ADDENDUM NO: 01

BID PACKAGE NO: Kitchen Work Rebid

PROJECT: North and South Decatur Jr. / Sr. High School Additions and Renovations

PROJECT NO: DATE: 02/16/2024 BY: Emery H. M. Hunt

AD201

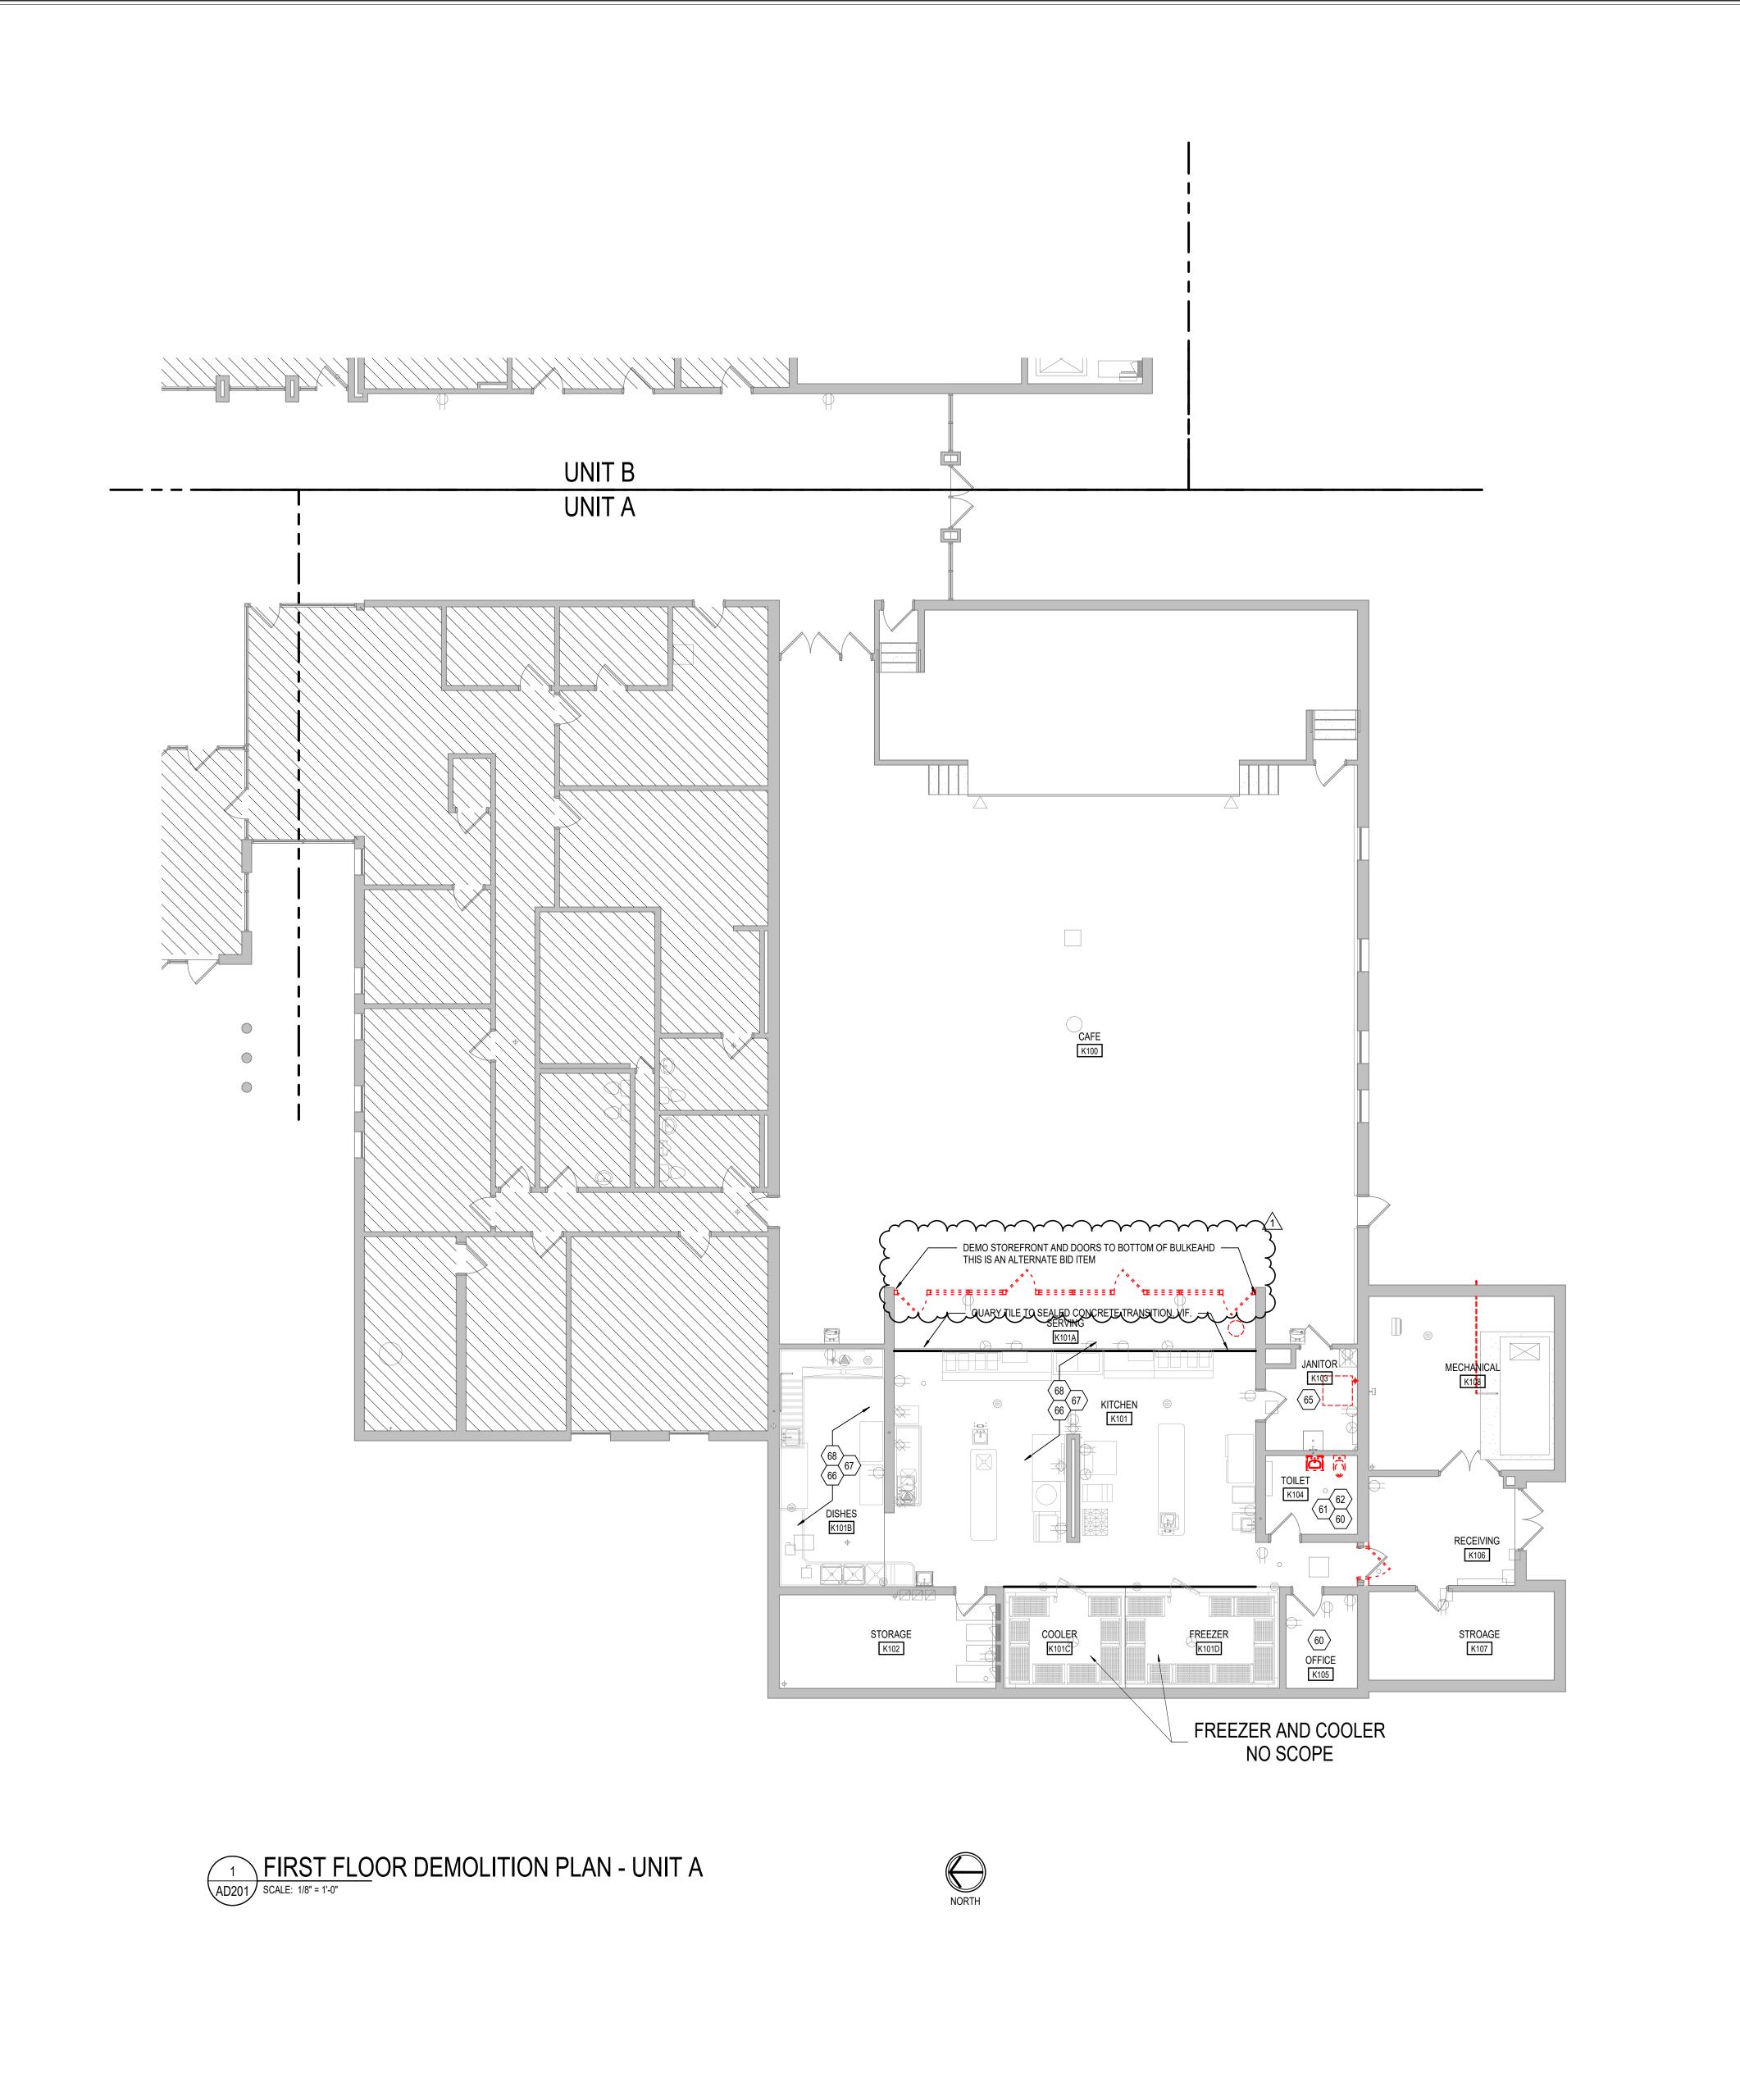
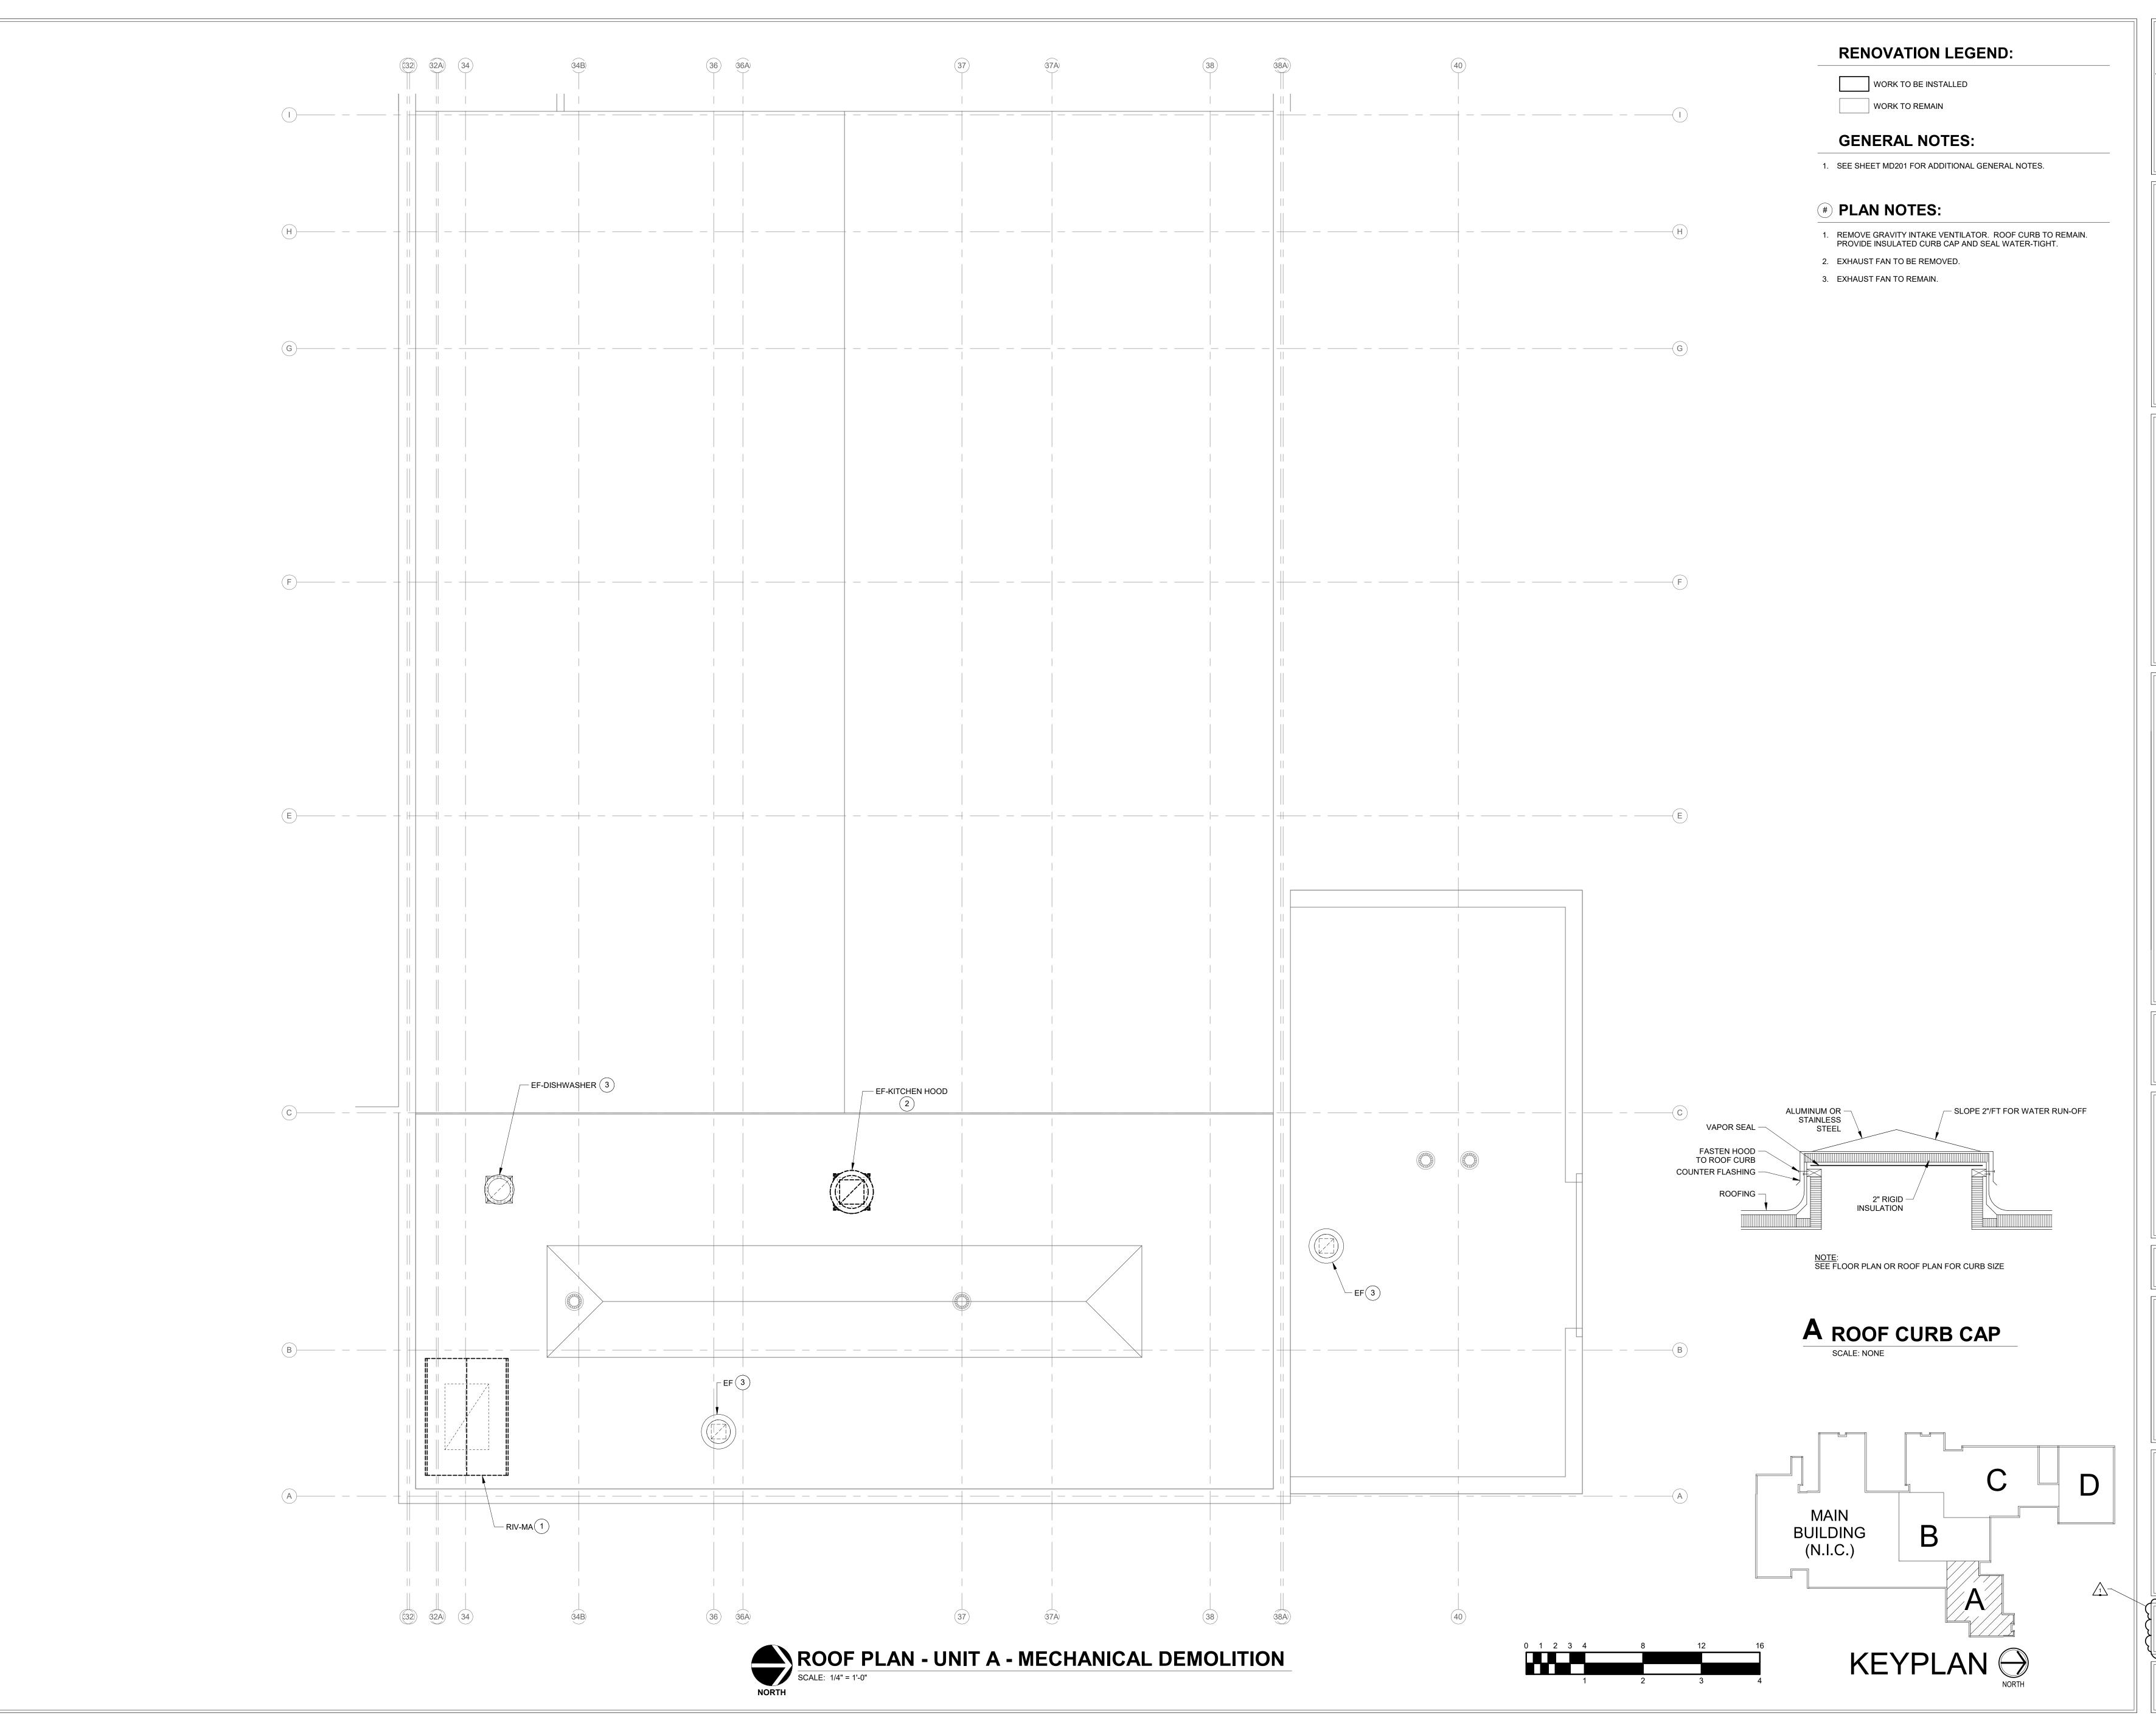
- A. For the alternate bid, show the serving line storefront and doors completely demolished.
- B. Revise demo note 68

MD21

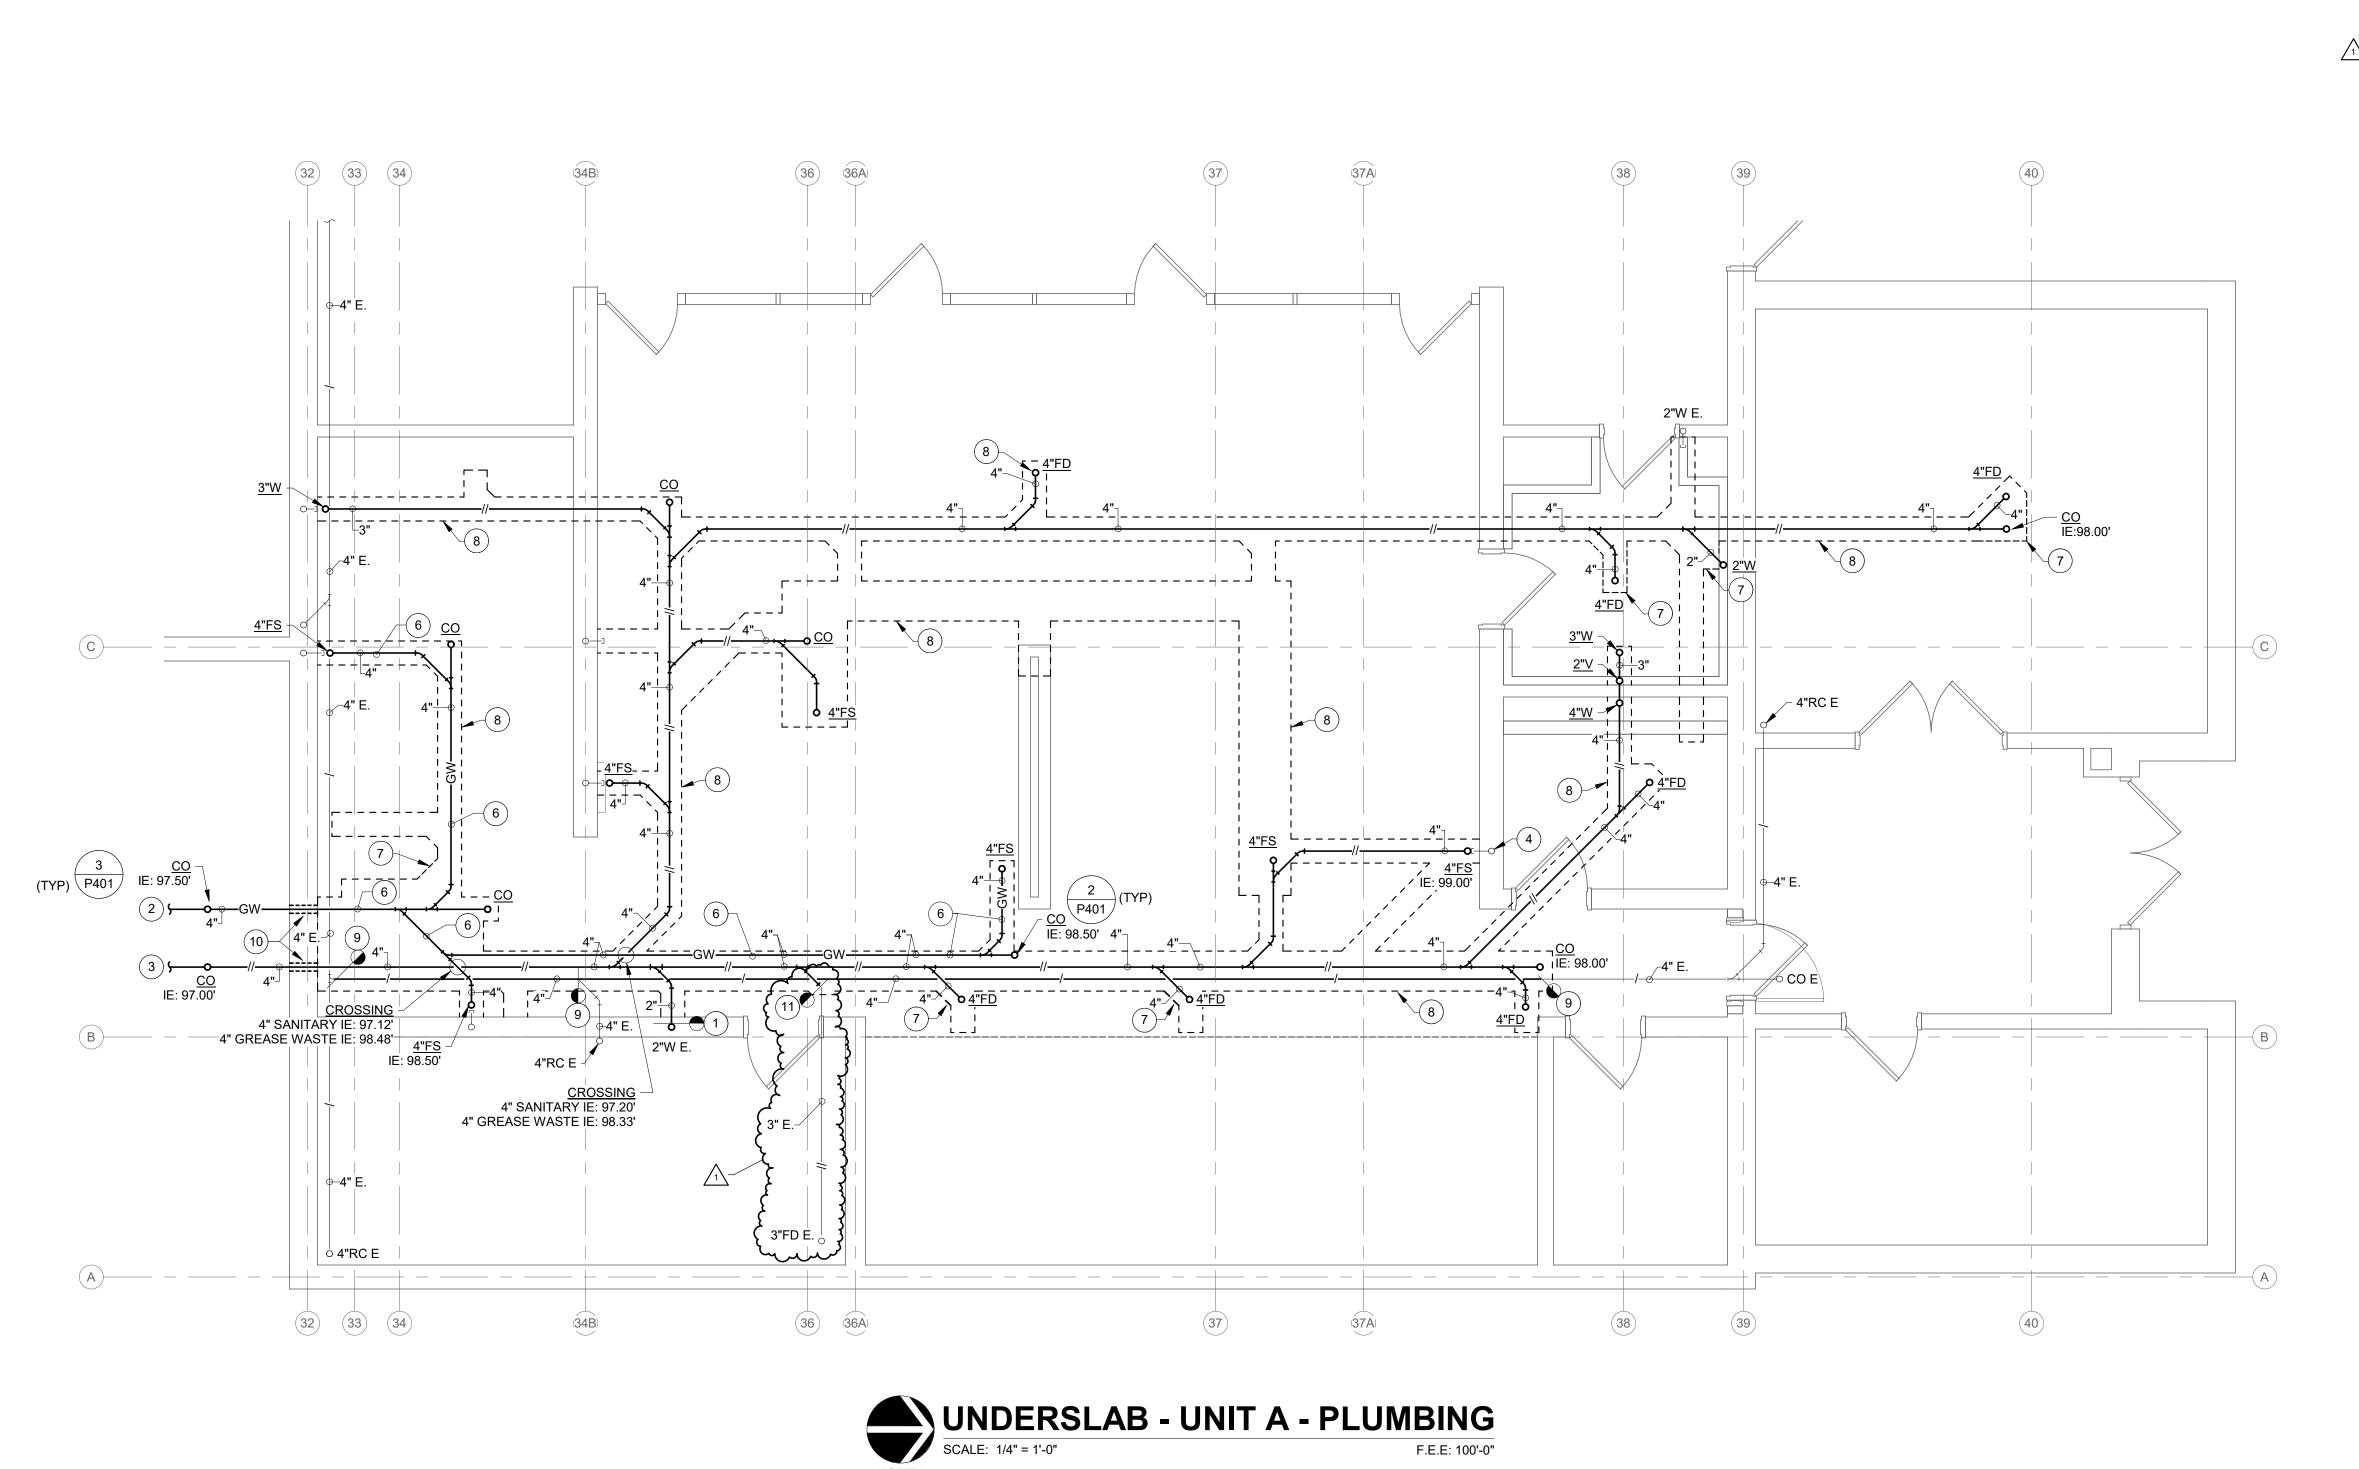
A. Add this sheet in its entirety.
